REQUEST FOR BOARD ACTION

HENDERSON COUNTY PLANNING BOARD

Combined Master and Development Plan for The Overlook at Waters Edge

Combined Master and Development Plan Review for The Overlook at Waters Edge Major Subdivision (File #2007-M05)

Map A: CCP Future Land Use Map

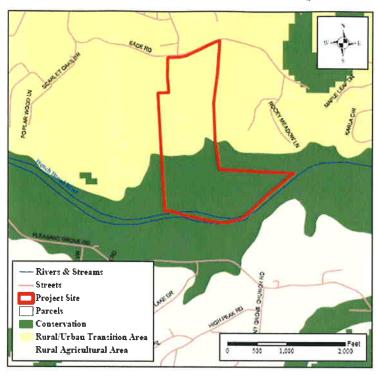
1. **County Comprehensive Plan (CCP).** The Future Land Use Map of the CCP shows the project site as being located within each of the following areas: Conservation Area and Rural/Urban Transition Area (RTA) (See Map A: CCP Future Land Use Map).

- Conservation Area. The conservation area designation is applied to the southern portion of the project site, largely because of the presence of floodplain and floodway in this area (See Attachment 2, Vicinity Map). The CCP states that conservation lands "are intended to remain largely in their natural state, with only limited development," and further that "such areas should be targeted for protection through regulations and incentives" (2020 CCP, Pg. 134). The Master and Development Plan indicates that most of the land in flooplain and floodway will be reserved for future use, and the applicant has suggested that this will be placed into an agricultural use. Certain lots (Lots 61-68 and 44) will also contain portions of floodplain and floodway. (See Master Plan Comment 3, below, regarding staff recommendations for these lots).

- Rural/Urban Transition Area. The Rural/Urban Transition designation of the Growth Management Strategy is applied to the project site. The RTA is intended to remain predominantly rural with a general density of five (5) or fewer acres per residential dwelling unit (average lot sizes of 5 or fewer acres per unit). According to the Master Plan, the project would have an average density of 1.48 units per acre (average lot size of 0.68 acres). The proposed densities/lot sizes are in keeping with those recommended by the CCP. The CCP states that, "the primary factor preventing urban development in the RTA is the absence of sewer and water service" (2020 CCP, Pg. 130). The plan indicates that public water and private sewer service will be available to the development. Presence of water and sewer may result in a reclassification of the project site to "Urban Services Area" which would also permit the proposed densities.

Map B: Draft Land Development Code Map

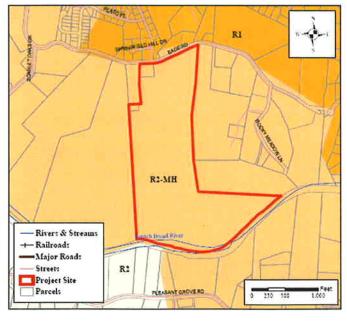
2. Land Development Code (LDC). According to Proposed Draft 8 of the Land Development Code Zoning Map the proposed project site for this development is located entirely in the Residential Zoning District 2 – Manufactured Housing (R2MH) (See Map B: Draft Land Development Code Map). The current draft of the Land Development Code (LDC) allows for a density of one (1) unit per acre (average lot size of one (1) acre) for single-family residential development and two (2) units per acre (average lots size of ½ acre) for multifamily development. According to the plan, the project would have an average density of 1.48 units per acre (average lot size of 0.68 acres). The applicant is proposing 68 singlefamily residential lots (which would require 68 acres) and an additional 45 townhome units (which would require 22.5 acres). The project site only contains 76.29 acres which is 14.21 acres fewer than the proposed development would require in order to achieve the proposed densities. This would not be in keeping with the densities generally proposed for the property by the Land Development Code, being that the proposed development is more dense than the LDC would allow. Since differences exist between proposed densities with the LDC and the CCP, if the LDC is adopted as proposed, the CCP may need to be amended to be consistent with the LDC. It should also be noted that the extension of private sewerage to the site may result in the property being zoned R1 which would permit the proposed densities.

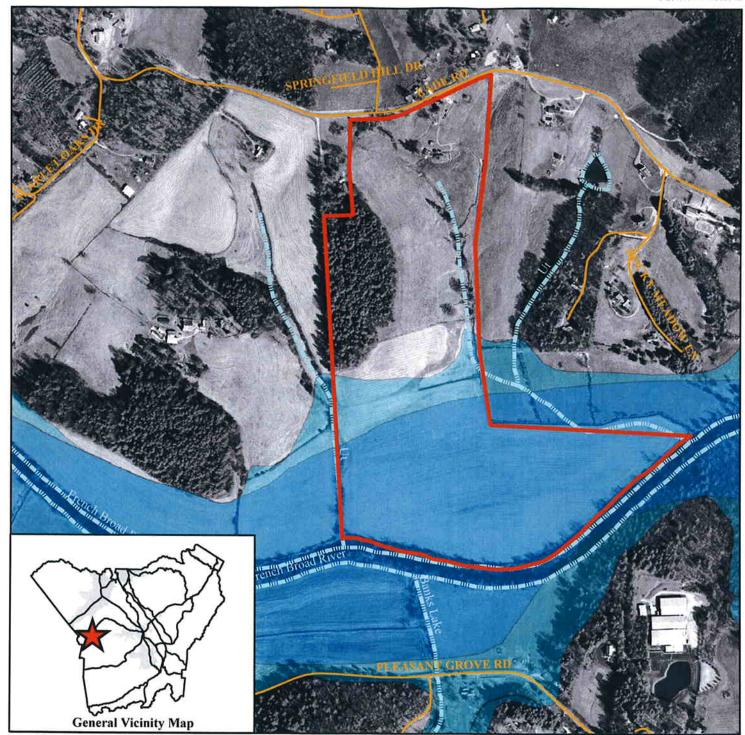
5. **Private Road Standards.** The applicant is proposing a combination of private residential collector roads and private local residential roads. The collector roads include Great Sky Way, Dancing Waters Terrace, and Waters Edge Drive (See Review Agency Comment 2, below). The local roads include River Breeze Circle and Rustling Water Way. The Applicant has provided two typical cross sections for the proposed roads, with and without valley gutter which both appear to be in compliance with §170-21 of the HCSO. The Applicant should indicate which typical will apply to the project prior to development plan approval.

The proposed collector roads meet all other requirements with the exception of the proposed centerline radii which must be 110 feet (it appears the applicant has proposed 90 foot centerline radii along Waters Edge Drive in the vicinity of Lot 45).

All of the subdivision roads must be designed and constructed to the minimum standards of §170-21 of the HCSO (§170-21 and Table 1).
